ENGINE - LP COMPRESSOR - REPLACE THE FAN CASE ASSEMBLY NO.1 RUBBER SEAL ASSEMBLY -
CATEGORY CODE 6 - MOD.ENG-72-0156

V2500-ENG-72-0156

SERVICE BULLETIN

Location of the No.1 Panel Rubber Seal and Sealant Position
Fig.1

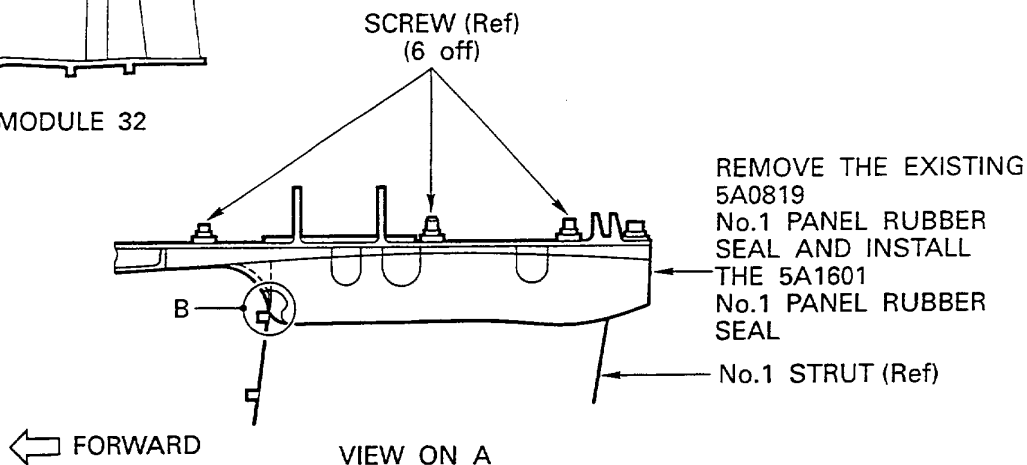
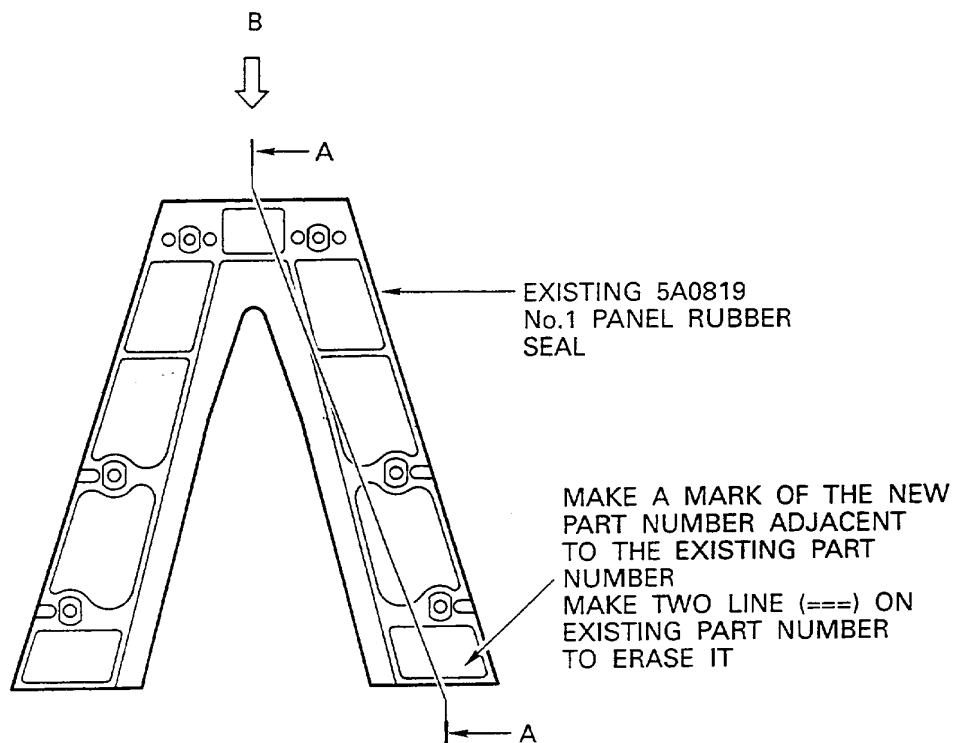
- (a) The existing 5A0819, No.1 panel rubber seal on No.1 strut with screws of the LP Compressor/Intermediate Case Module is replaced with the 5A1601, No.1 panel rubber seal with sealant in to the clearance AA (See Figure 1).
- (b) Local cut of interference area on the existing No.1 panel rubber seal and put the sealant in to the clearance AA when assembled (See Figure 1 and 2).

*FILL THE SEALANT IN TO
CLEARANCE AA BETWEEN THE
No.1 STRUT AND FRONT END
OF No.1 PANEL RUBBER SEAL

(a) Install the 5A1601, No.1 panel rubber seal on to the LP Compressor/Intermediate Case Module in accordance with following procedures (Refer to Figure 1):

- 1 Attach the 5A1601, No.1 panel rubber seal to the fan case and safety the seal with existing six screws (Refer to Figure 1).

(b) Torque the screws to 75 to 85 lbfin (8,50 to 9,60 Nm).

(c) Fill the clearances between the No.1 strut and the rubber seal with silicone rubber compound in accordance with following procedures (Refer to Figure 1):

- 1 Use a clean cloth or a soft brush made moist with CoMat 01-076, Methylethylketone to clean clearance AA between the No.1 strut and the front end of the No.1 rubber seal.
- 2 Apply a thin layer of CoMat 08-014 primer to the areas with a soft brush. Air dry for 30 minutes minimum.

- 3 Fill the CoMat 08-045 silicone rubber compound in to the clearance AA with a sealant dispenser.
- 4 Press the silicone rubber compound in to position and make smooth with a spatula.

Modification of the No.1 Panel Rubber Seal
Fig.2 (Sheet 1 of 2)

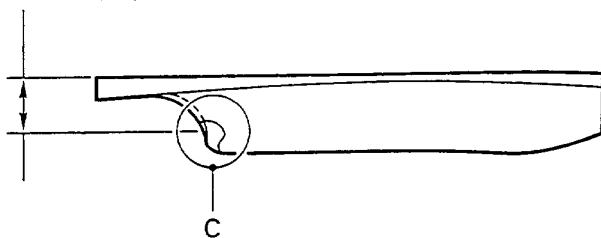
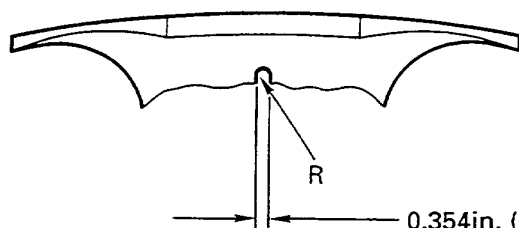
(2) Existing 5A0819, No.1 panel rubber seal can be reworked to the new configuration (See Figure 2).

1.319in. (33,5 mm) THRU 1.359in. (34,5 mm)

REMOVE THE UNWANTED
MATERIAL AROUND HERE
0.019in. (0,50 mm) TO 0.039in. (1,00 mm)

0.354in. (9,00 mm)
THRU
0.433in. (11,00 mm)

| Procedure | Supplementary Information |
|---|---|
| (a) Prepare the Hand Grinder equipped small cutter which diameter is less than 0.197in(5,00mm). | Hand Grinder and cutter are facility equipment tools, and see Reference (3), RB010 and RB012 respectively. |
| (b) Make a temporary mark of the slot profile to be cut on the leading edge of fillet on the No.1 panel rubber seal using pencil or crayon. | See Reference (4), Control No./TASK No. 70-09-01-400-501. |
| (c) Remove the unwanted material from marked area (See step (b)) on the No.1 panel rubber seal using Hand Grinder. | Refer to Figure 2. |
| (d) Remove burrs from the leading edge of fillet on the No.1 panel rubber seal. | Use the knife. |
| (e) Make the material countours smooth. | Use the file. |
| (f) Examine the reworked No.1 panel rubber seal. | The leading edge of fillet of part must have no cracks. |
| (g) Make a mark of the new part number adjacent to the existing part number. Make two lines (==) on existing part number to erase it. | Old part No. New part No. 5A0819 5A1601 Refer to Figure 1, and Reference (4) Control No./TASK No. 70-09-00-400-501. |
